Metropolitan Historic Zoning Commission
Sunnyside in Sevier Park
3000 Granny White Pike
Nashville, Tennessee 37204
Telephone: (615) 862-7970
Fax: (615) 862-7974

STAFF RECOMMENDATION
2615 Sunset Place
October 16, 2019

Application: New Construction—Addition and Outbuilding; Setback determination
District: Hillsboro-West End Neighborhood Conservation Zoning Overlay
Council District: 18
Base Zoning: RS7.5
Map and Parcel Number: 10415010400
Applicant: Torne White
Project Lead: Melissa Baldock, melissa.baldock@nashville.gov

Figure 1. 2615 Sunset Place.

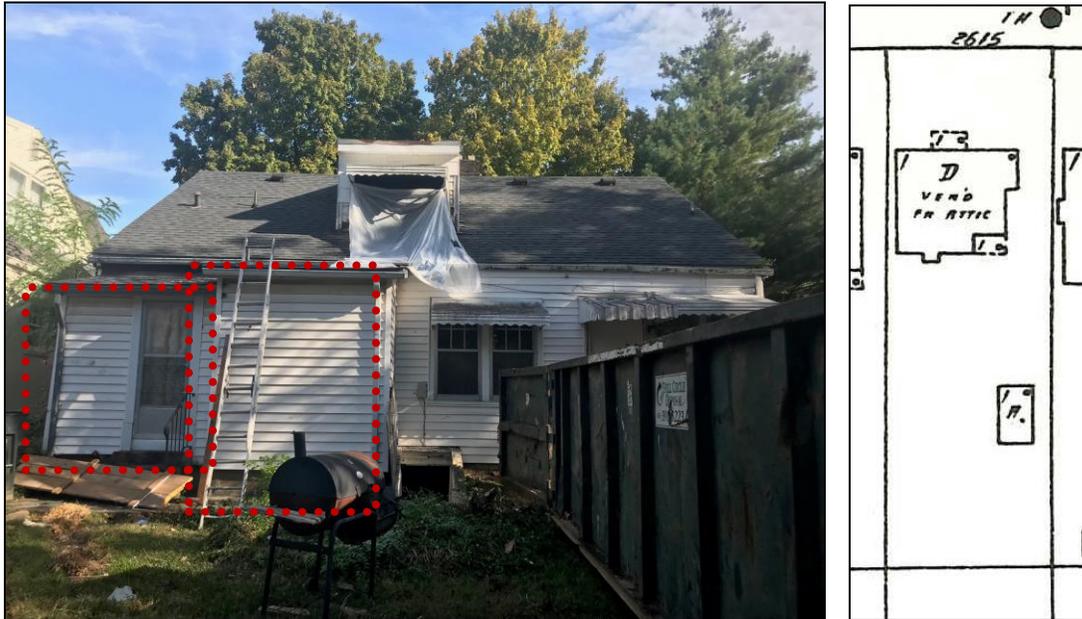
Background: 2615 Sunset Place is a c. 1938 brick Tudor bungalow that contributes to the historic character of the Hillsboro-West End Neighborhood Conservation Zoning Overlay (Figure 1).

Figure 6. The site plan shows how the historic house does not meet the base zoning side setback on the left, and how the house is skewed slightly on the lot. The addition will be as little as two feet (2') from the side property line.

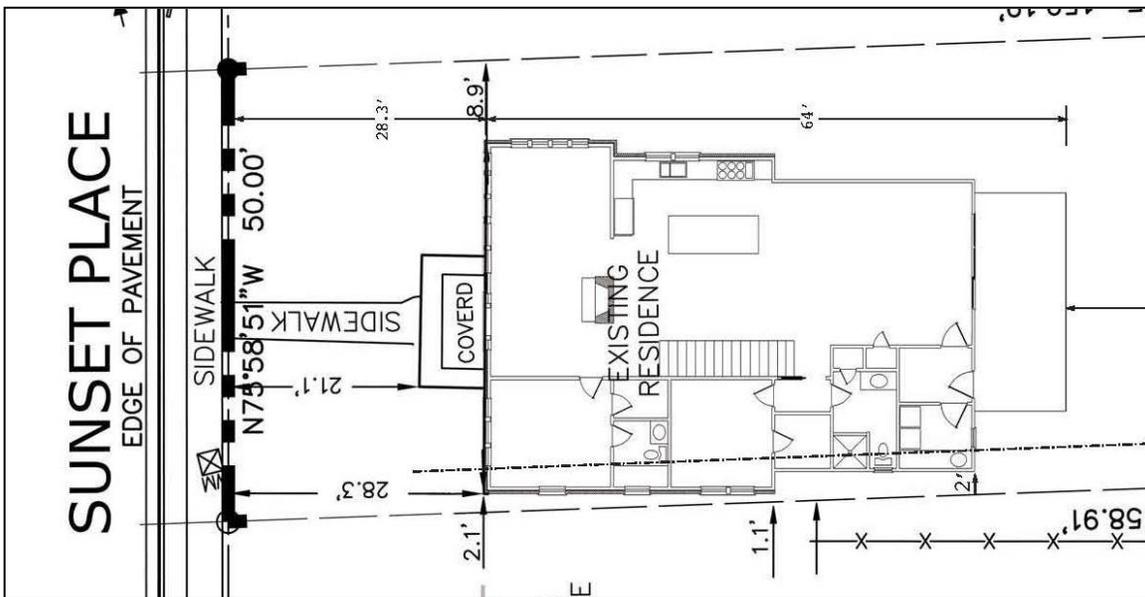
Setback & Rhythm of Spacing: The addition will be approximately fourteen feet, six inches (14'6") from the left-side property line and sixty-five feet (65') from the rear property line, both of which meet the design guidelines. The historic house is shifted to the right side of the lot and is skewed slightly, so it is as little as one foot (1') from the right property line; this does not meet the base zoning setback of five feet (5').

The addition is inset two feet (2') from the historic house, but because the house is skewed slightly on the lot, the addition will be situated two feet (2') from the side property line at its closest point (Figure 6). This does not meet the five-foot (5') base zoning setback, and the project therefore requires a setback determination. Staff is supportive of the setback determination because the addition is no wider than the historic house, and is in fact, narrower than the historic house. The portion of the addition that does not meet the five-foot (5') side setback is relatively modest in depth at just twenty-two feet (22'). The Commission has approved side setback determinations in similar situations where the historic house does not meet the base zoning setback and the addition is no wider than the historic house.

Staff finds that the addition's setbacks meets Sections II.B.1.c. and II.B.2. of the design guidelines.

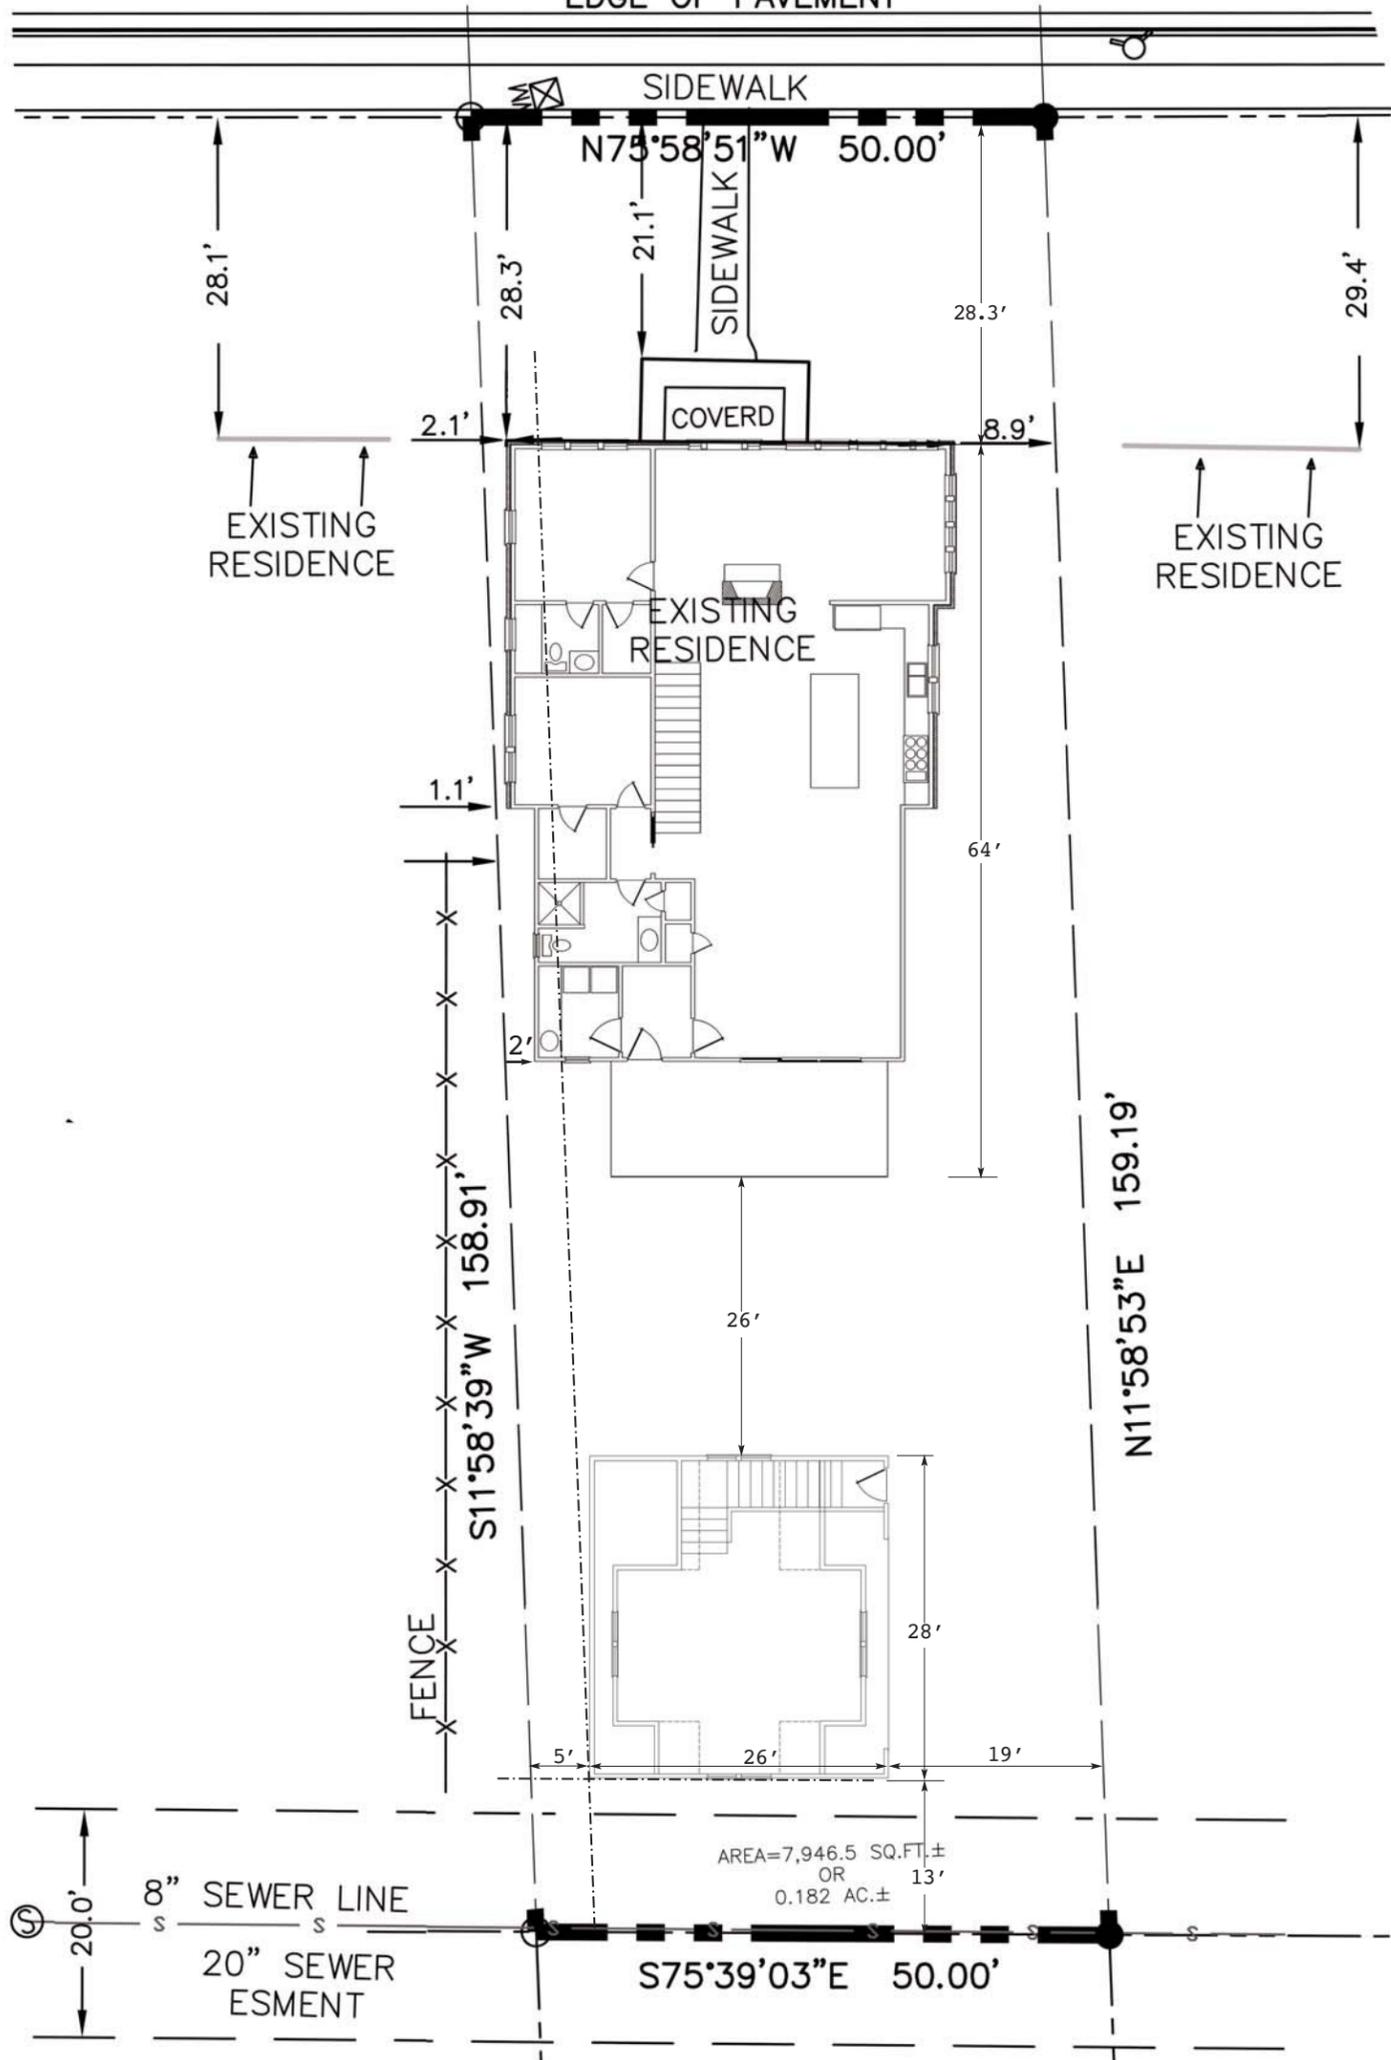
Partial Demolition: The applicant proposes to remove an existing rear extension and to alter openings in the gable field on the left façade. At the rear, the applicant plans to

remove a one-story shed roof projection (Figure 2). The projection's date of construction is not known, but only a part of it appears in the 1957 Sanborn Map (Figure 3.). Staff finds that this existing addition, with its shed roof form, location at the rear, and invisibility from the street, is not an architecturally or historically significant feature of the house Staff therefore finds that its removal meets the design guidelines.

Figures 2 & 3. In the photo, the left portion of the addition does not appear in the 1957 Sanborn Map (which is Figure 3), while the right portion of the addition does. Staff finds that their removal is appropriate.

On the left side of the house, the applicant intends to remove a doorway in the gable field and replace it with a paired window opening (Figure 4). Removing and altering window and door openings is considered partial demolition. In this case, staff is supportive of the partial demolition, as the door in the gable field is not an original feature of the house. The new window openings will match the double window opening on the right side of the house.

Also on the left side of the house, there is an existing enclosed porch/sun room. The applicant intends to shorten the existing door opening to make it match the size of the window openings to the right (Figure 5). Staff finds this to be appropriate because the area will still be an opening, and the doorway is not a significant feature of the house. The area will still read like an enclosed porch/sunroom.

Figure 4 (left) shows the door opening that will become a paired window opening. Figure 5 (right) shows the door opening that will be shortened to match the size of the window openings to its right.

Staff finds that the proposed partial demolition meets Section III.B.2 for appropriate demolition and does not meet section III.B.1 for inappropriate demolition.
